Subject: Submittal of the Response to the Notice of Disapproval for the Bandelier Tuff Unit 4 Background Study Report

Response to the Notice of Disapproval for the Bandelier Tuff Unit 4 Background Study Report, Los Alamos National Laboratory, EPA ID No. NM0890010515, HWB-LANL-11-069, Dated October 11, 2011

Statistical Tests and Box Plots for Eleven Inorganic Chemicals Identified at TA-49

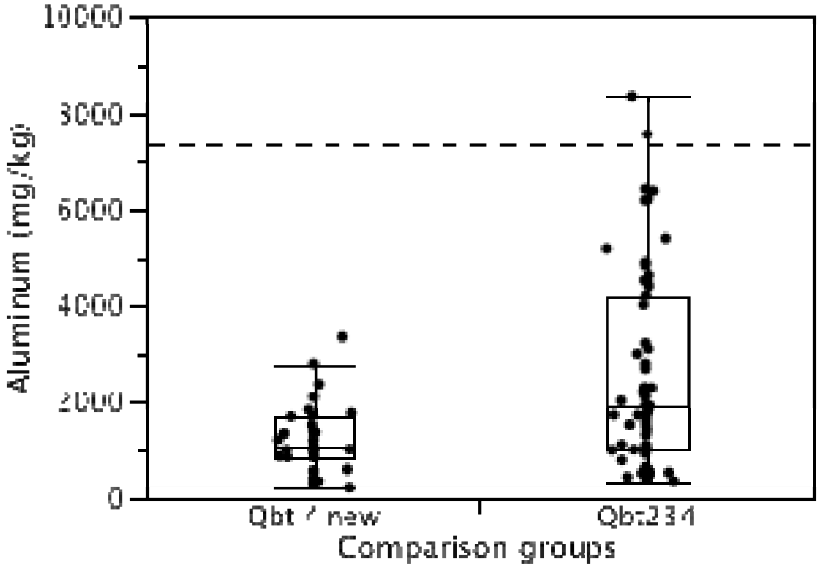
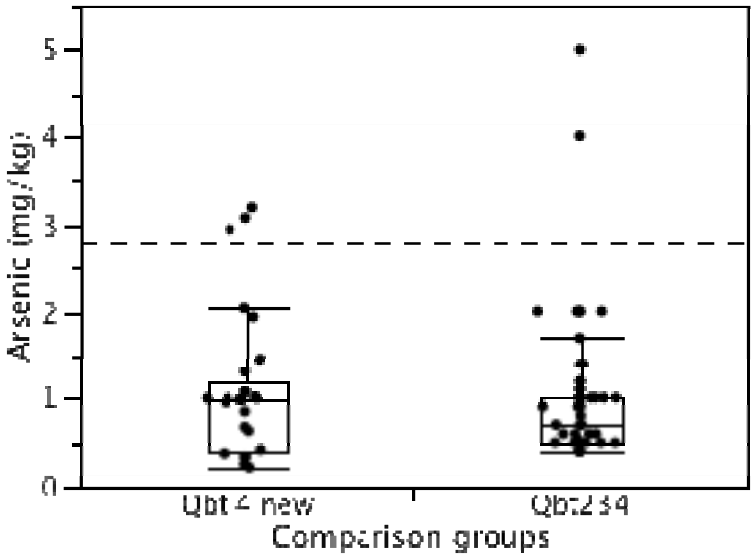
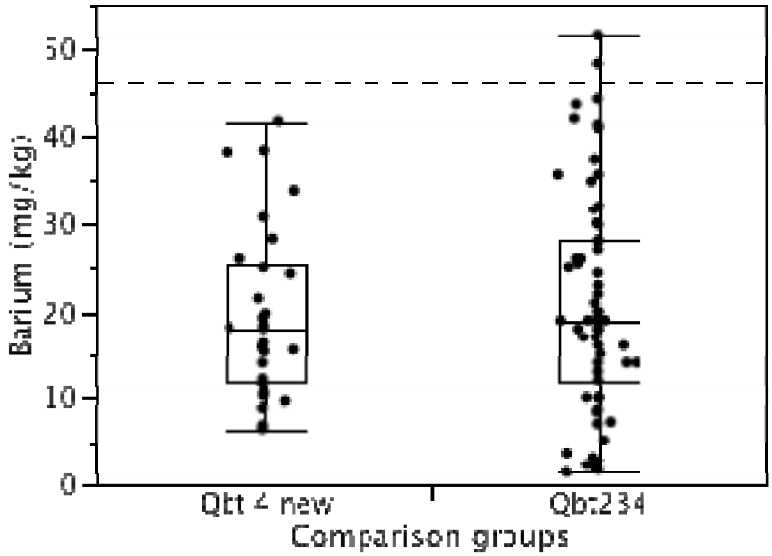
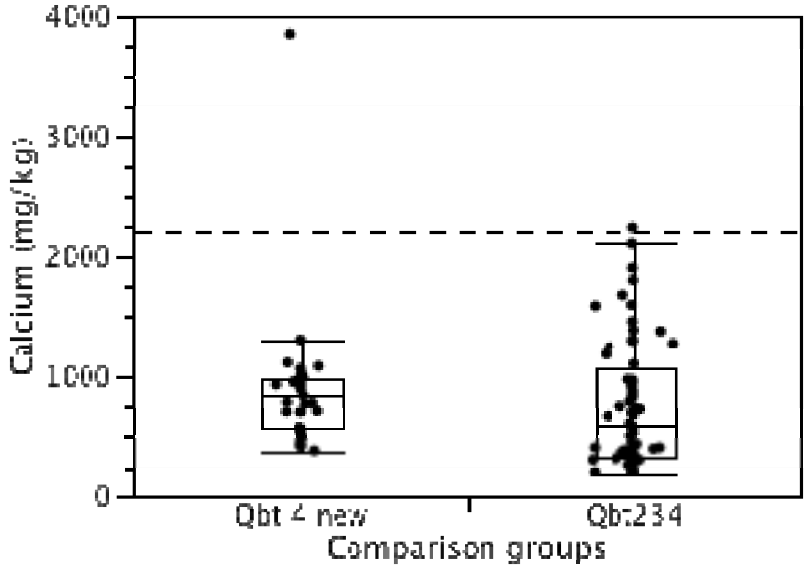
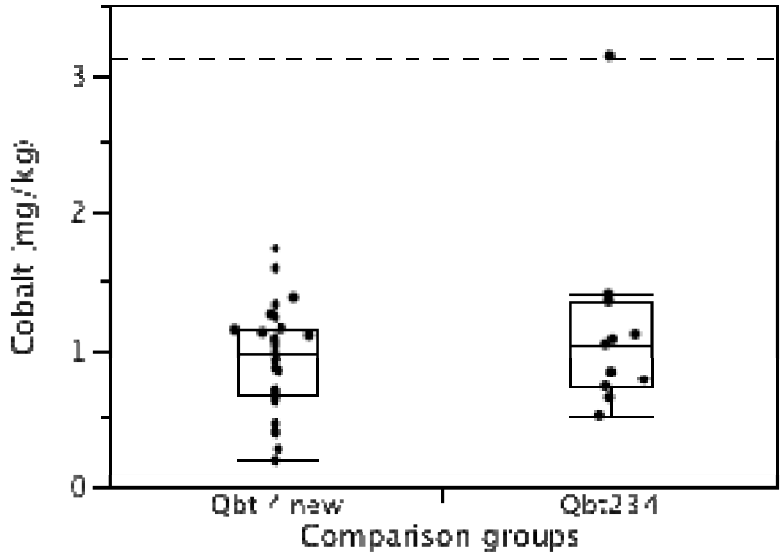
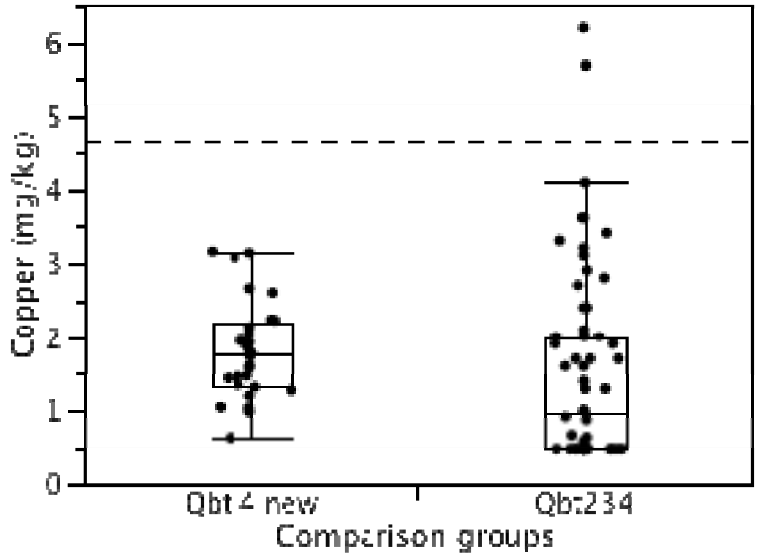
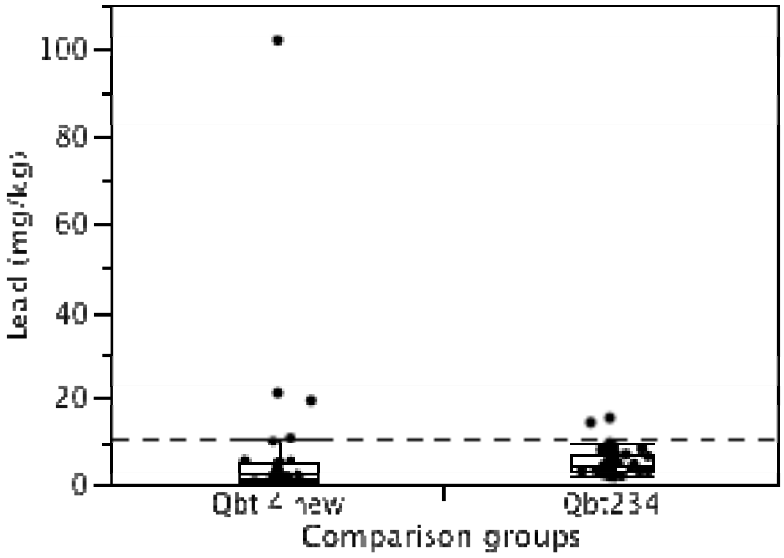
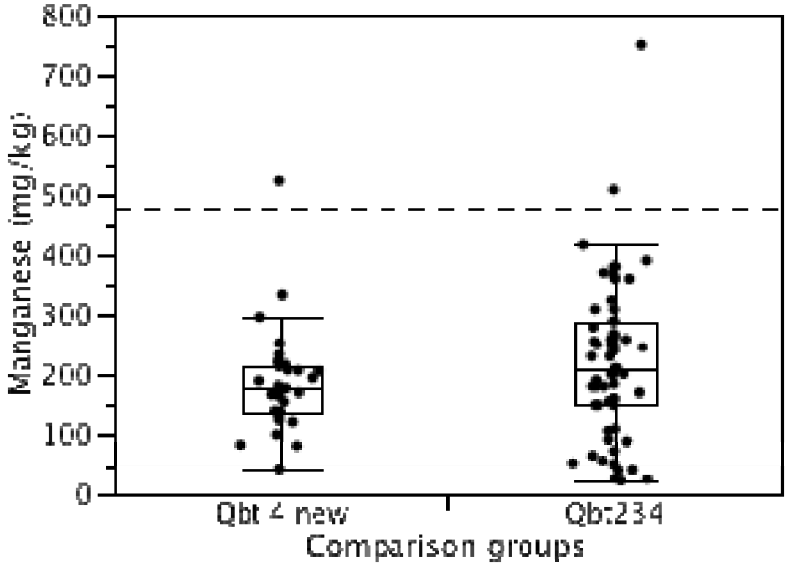
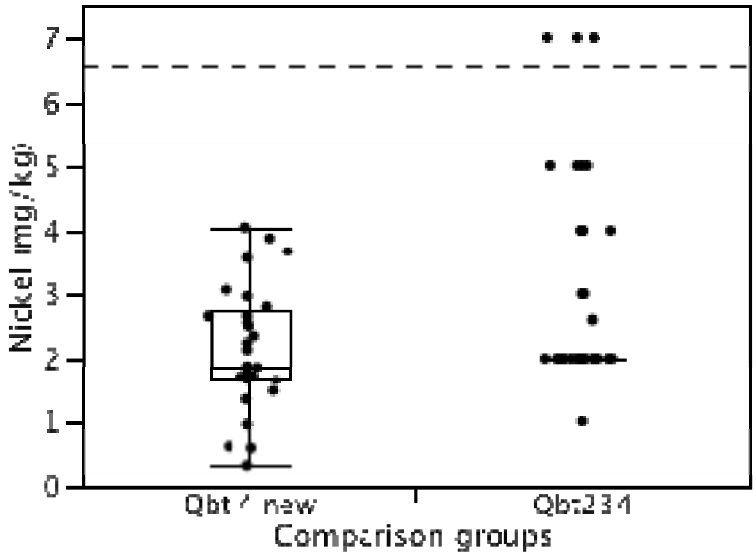
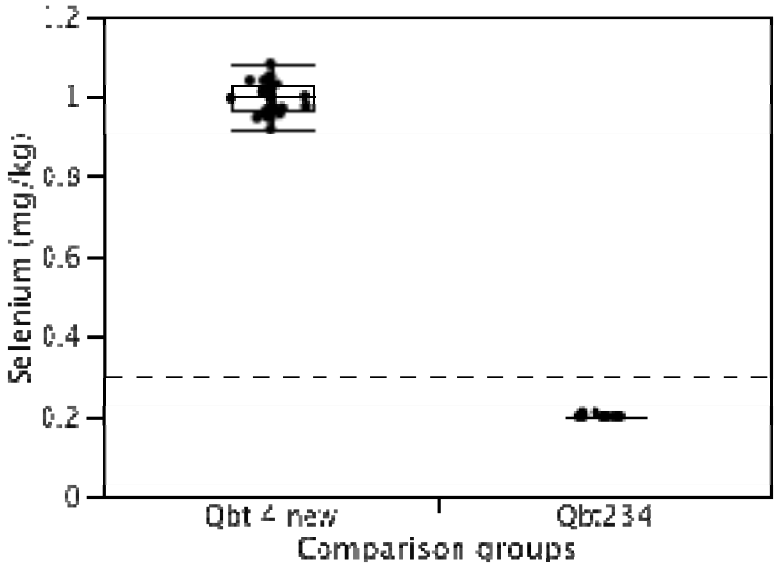
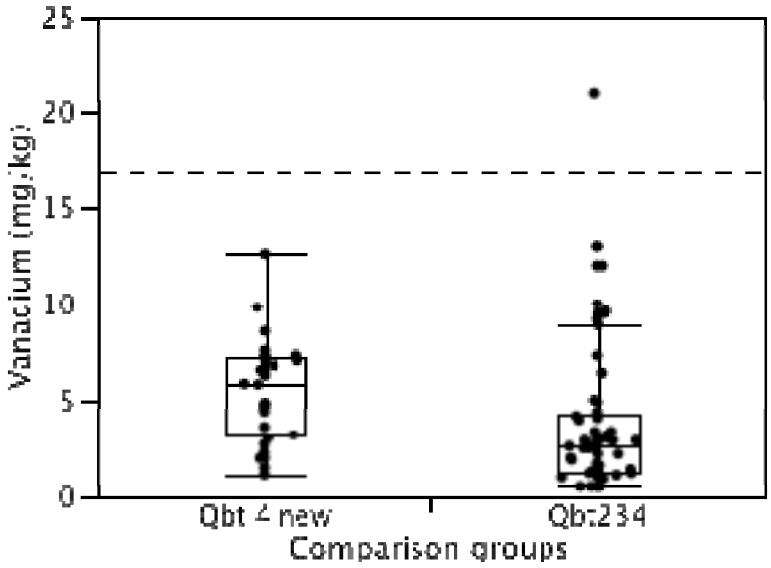
1. *The metals data for the background study are representative of leachable element concentrations, and the analytical methods used in the current study appear consistent with the methods used in the original background study report. The results for the metals, provided in Table 4.1-1, and the discussion of these data presented in Section 4.1.1 of the report, indicate that the Qbt 4 data are essentially the same as the previously established background. It is not clear how this determination was made. It appears that a statistical evaluation of the data was not conducted and, since the Qbt 4 data were not significantly above the established background levels, it was assumed that the Qbt 4 was representative of the existing background data. However, in reviewing at the data in both Tables 4.1-1 (metals) and 4.1-5 (radionuclides), the Qbt4 data appear to actually be lower than the established background levels (with the exception of the data in Tables 4.1-2 and 4.1-6). Clarify how it was determined that the new Qbt 4 data are actually reflective of the established background data. For example, did the Permittees make this determination after conducting statistical comparisons between the data sets.*

Box plots of the new Qbt 4 data and the existing Qbt 2, 3, 4 data were reviewed during preparation of the background study report to aid in interpretation of the data but were not included in the report. These box plots and results of statistical analyses for the 11 inorganic chemicals specifically identified in the TA-49 investigation report as possibly having background concentrations above Qbt 2, 3, 4 BVs (aluminum, arsenic, barium, calcium, cobalt, copper, lead, manganese, nickel, selenium, and vanadium) are presented in Attachment 1 to this response. The statistical analyses were performed to determine whether there were statistical differences between the Qbt 4 background study data and the existing Qbt 2, 3, 4 data. Arsenic, barium, cobalt, manganese, and nickel showed no statistical differences compared with the existing Qbt 2, 3, 4 data set. Concentrations for the new Qbt 4 samples were less than the existing Qbt 2, 3, 4 data for aluminum and lead and concentrations for the new

Qbt 4 samples were greater than the existing Qbt 2, 3, 4 data for calcium, copper, selenium, and vanadium. Even for those inorganic chemicals with statistical differences, the overall range of the new Qbt 4 background samples overlaps with the existing Qbt 2, 3, 4 data. Thus, the existing Qbt 2, 3, 4 background data appear to be representative of background concentrations in Qbt 4.

Box Plots of XRF Analyses for Selected Minor and Trace Elements at TA-49

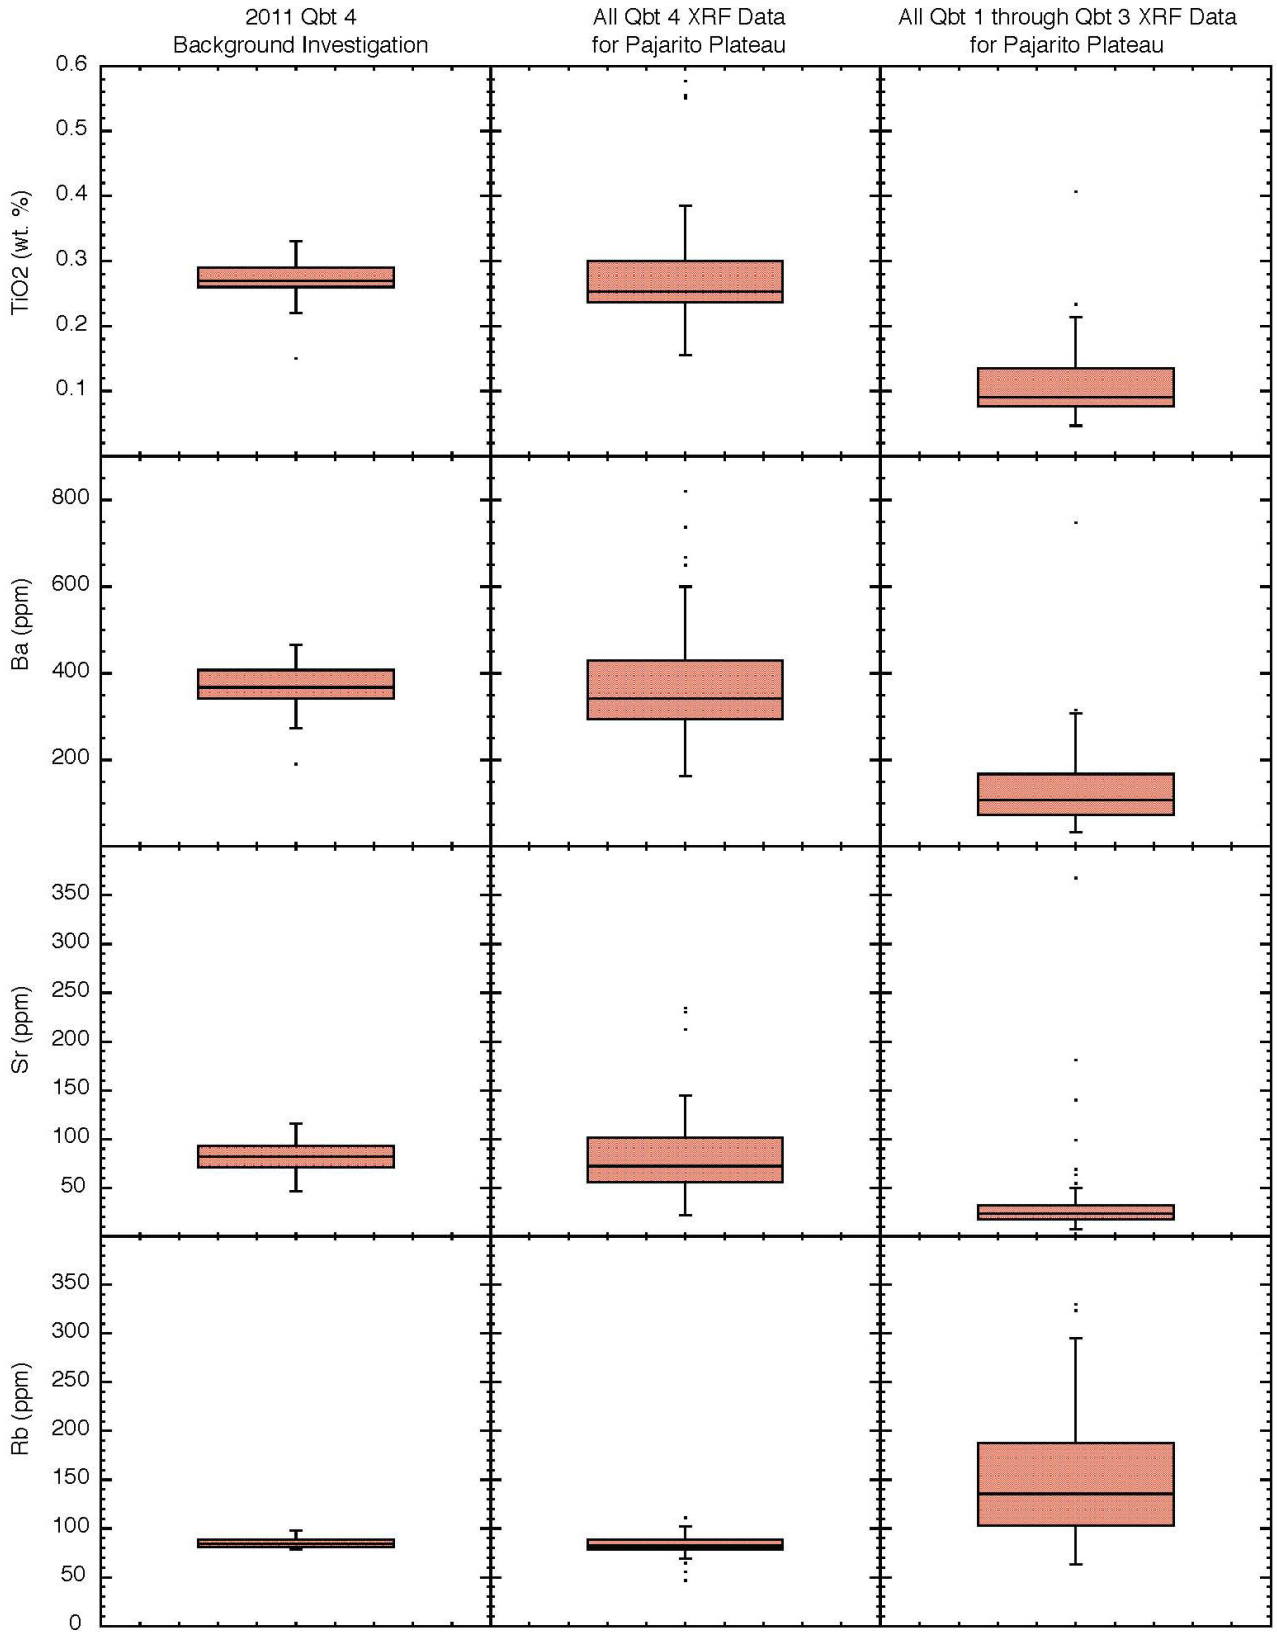
2. *In Section 5.0, there is mention of previously collected data that was analyzed using X-ray fluorescence (XRF) and that these data indicated higher concentrations than the established background. As part of the Qbt 4 study, samples at the bottom of the borings were collected and analyzed using XRF. The Work Plan for Determining Background Concentrations of Inorganic Chemicals in Unit 4 of the Bandelier Tuff (Work Plan, p 5) stated that "[s]amples will also be submitted for analysis using X-ray fluorescence (XRF) to collect data to compare with historical XRF total metal analysis data to Qbt 4." It is not clear whether a comparison was conducted between the two XRF datasets. The Permittees must discuss how the Qbt 4 XRF data compared to the past data referred to in this Section.*

2. As described in the work plan for the Qbt 4 background study, x-ray fluorescence (XRF) analysis was proposed to confirm the samples collected during the background study were from Qbt 4 (LANL 2010, 111504, p. 5). Although the major-element chemistry of subunits making up the Tshirege Member of the Bandelier Tuff is relatively uniform, minor ,and trace element abundances vary systematically as a function of stratigraphic position. In general, XRF whole-rock concentrations of minor and trace elements such as barium (Ba), strontium (Sr), titanium (TiO_2), zinc (Zn), and zirconium (Zr) tend to increase upsection (i.e., in higher stratigraph units), whereas incompatible elements such as niobium (Nb) and rubidium (Rb) tend to increase downsection (i.e., in lower units) (Broxton et al. 1996, 054948). The most pronounced chemical changes occur across the Qbt 3/Qbt 4 contact, making the identification of Qbt 4 based on XRF analyses relatively straightforward.

Twenty-nine of the 30 XRF samples collected for the 2011 Qbt 4 background study have chemical compositions equivalent to those for historical Qbt 4 samples collected throughout the Pajarito Plateau. The XRF data for 2011 Qbt 4 background samples was used to identify one chemical outlier in the Qbt 4 background data set (sample RE67-11-9819 in borehole 67-614317); this sample was subsequently reclassified as unit Qbt 3 based on its chemistry (LANL 2011, 206327, pp. 5–6). Attachment 2 to this response presents box plots of XRF analyses for selected minor and trace elements and shows that compositions of the 2011 Qbt 4 background samples are comparable with plateau-wide Qbt 4 samples. Attachment 2 also shows that Qbt 4 samples are readily distinguishable from plateau-wide Qbt 1 through Qbt 3 samples, which occur lower in the stratigraphic section. These data indicate the 2011 Qbt 4 background study samples are representative of Qbt 4 throughout the Pajarito Plateau.

Box Plots Comparing XRF Analyses for 2011 Qbt 4 TA-49 Background Investigation Samples to 1998 LANL Qbt 4 Background Report Samples

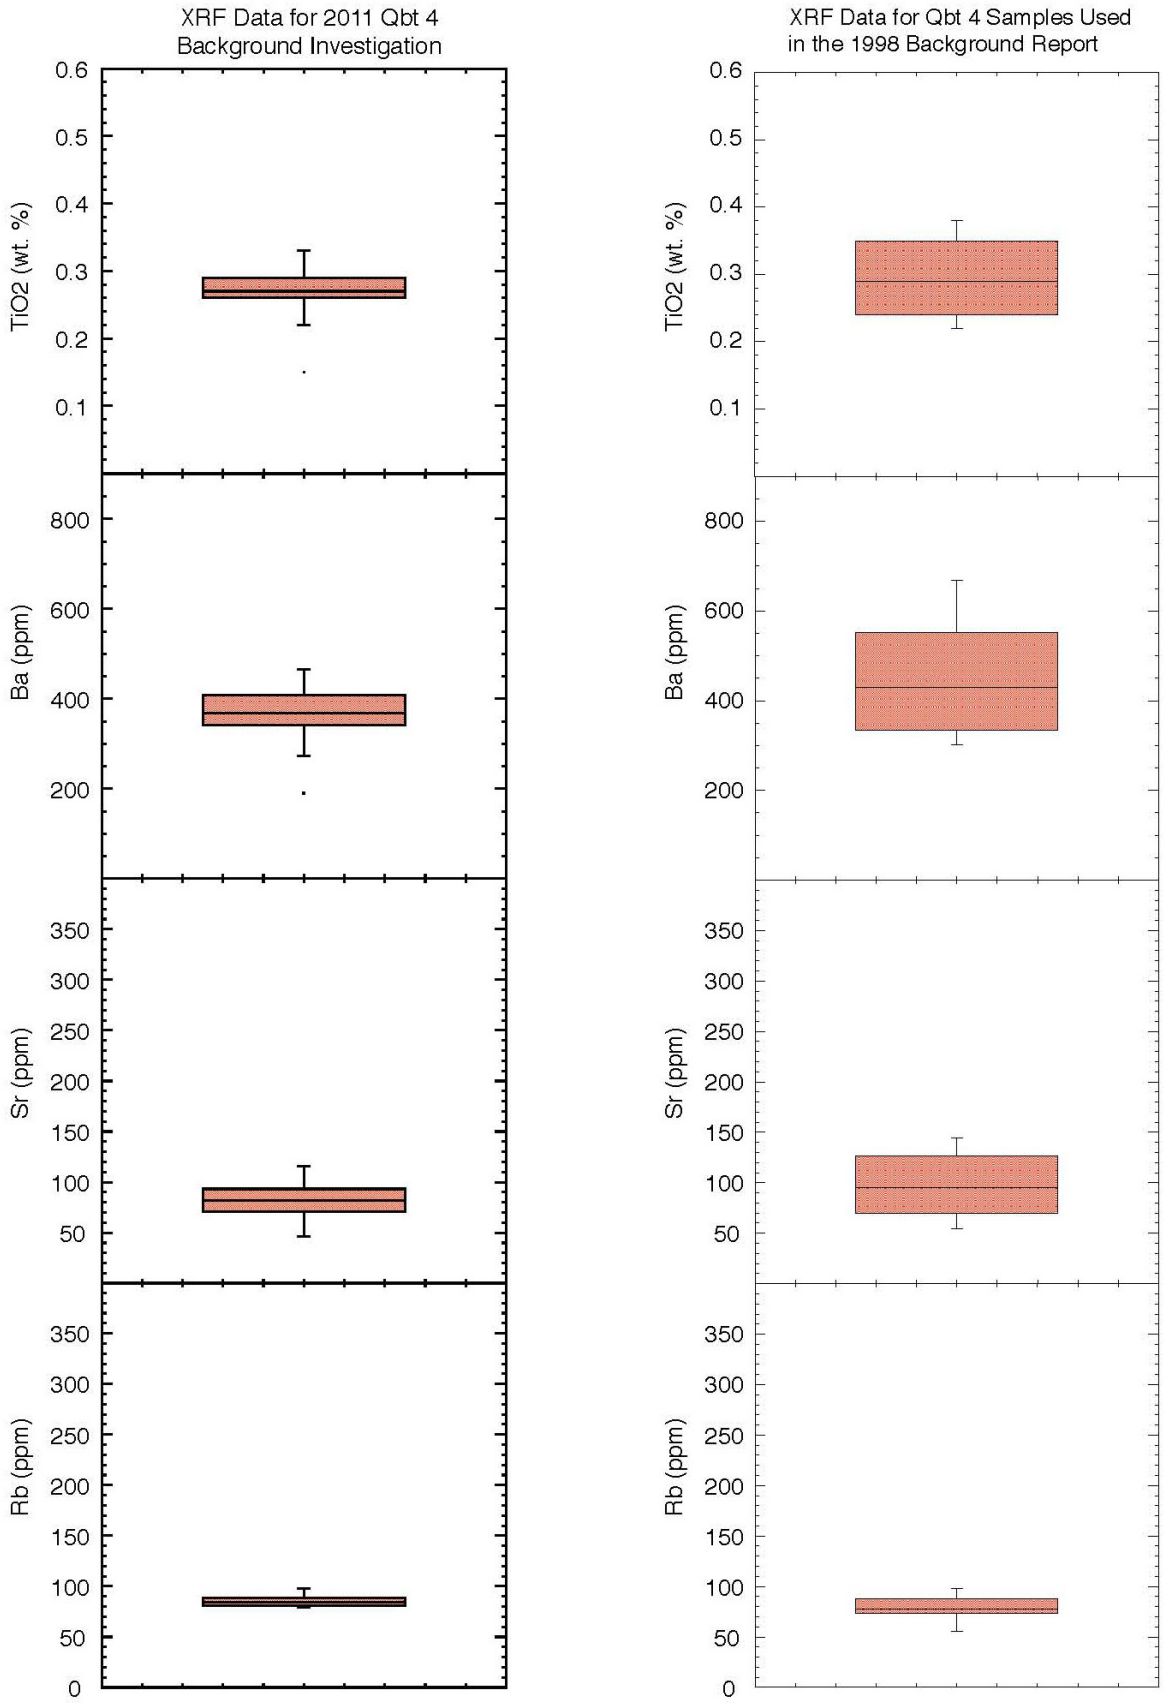
3. *It is not clear how the conclusion was made that the results from XRF confirm that the Qbt 4 data are representative of the existing background data. Explain what the data were compared to in deriving this conclusion.*

3. Attachment 3 to this response presents box plots that compare XRF analyses for the 2011 Qbt 4 background study samples with those for Qbt 4 samples used in the Laboratory's background report (LANL 1998, 059730). Qbt 4 XRF analyses for both data sets are chemically equivalent, supporting the interpretation that 2011 Qbt 4 background study samples are representative of Qbt 4 samples used to obtain the existing background data.
